Carbon Price Senior Task Force Base Case Review

October 27, 2020

Brian Megali
Senior Manager, Strategic Initiatives

PJM's Power Price Outputs Vary Widely from Market Prices

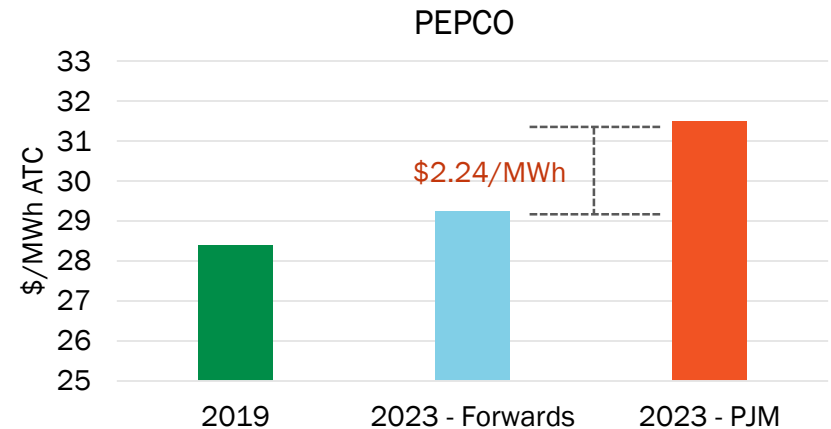
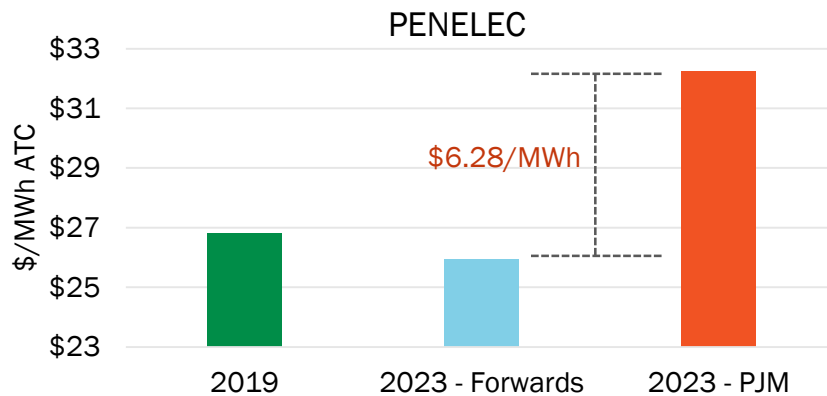
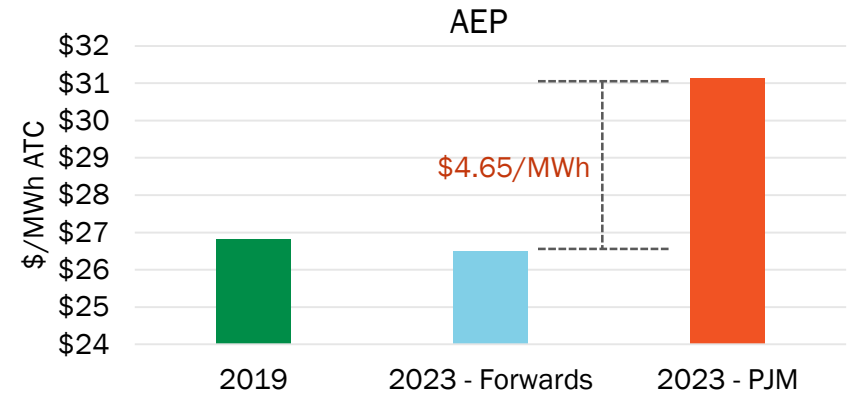
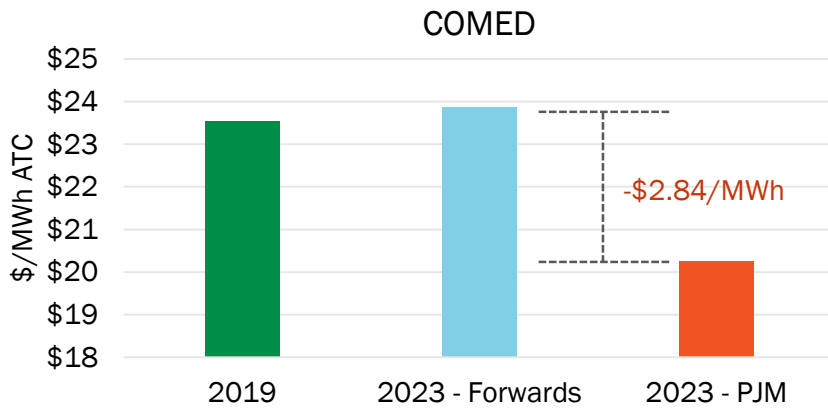
PJM's model produces ComEd prices well below forward prices and eastern prices well above forward prices

PJM's Model Yields an AEP-COMED Spread 3x Observed Values

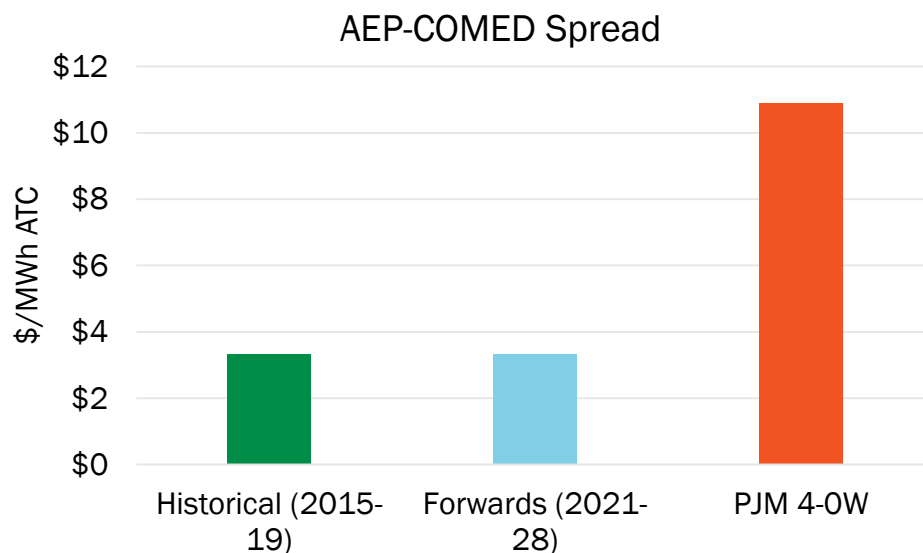
- PJM's model produces price spreads of over \$10/MWh, much greater than both historical and forward-looking spreads
- The outsized price spread between ComEd and the rest of the RTO in PJM's modeling suggests that ComEd fossil units will continue running and exporting to the east even with a carbon price added to dispatch costs
- If the model produced spreads consistent with observed values, ComEd fossil units would be less competitive after incorporating a carbon price.

PJM's Model Yields Counterintuitive Generation Dispatch in IL

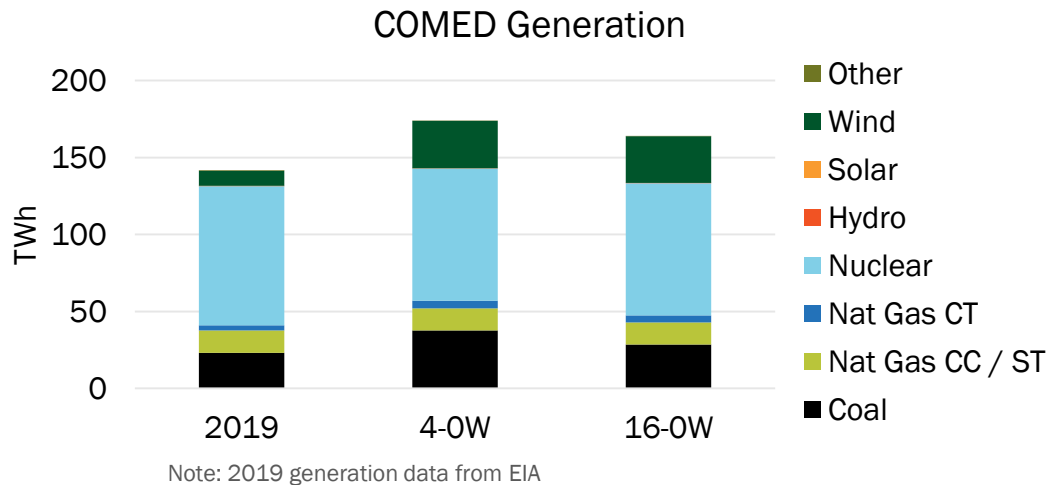
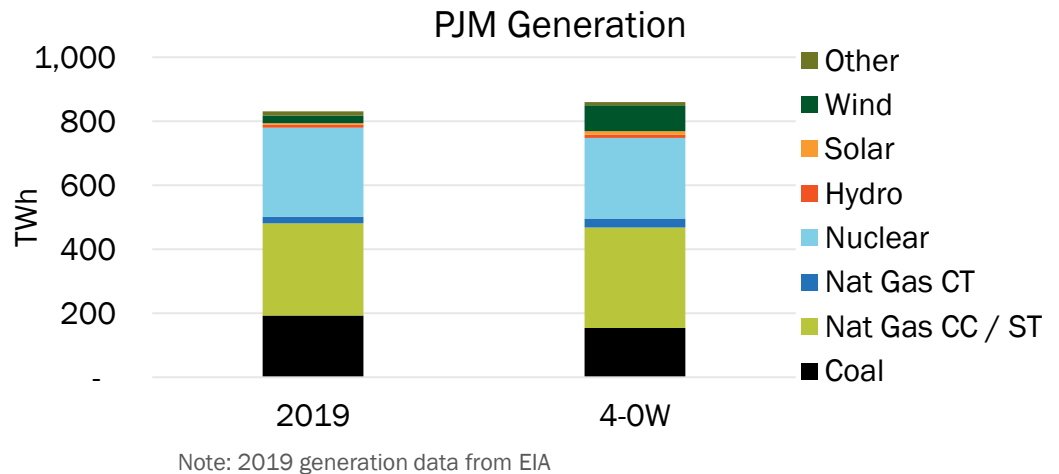
- Dispatch in PJM's modeling suggests Illinois generation output, especially coal, would *increase* relative to historical levels with a carbon adder
- Conversely, PJM's modeling shows RTO-wide generation outputs that are generally consistent with history
- The PJM modeling disparities occur even after updating the Market Efficiency Case stack assumptions, including coal retirements, new gas builds, and lower nuclear capacity

PJM modeling suggests that Illinois coal generation output would *increase* relative to recent history even with a carbon price
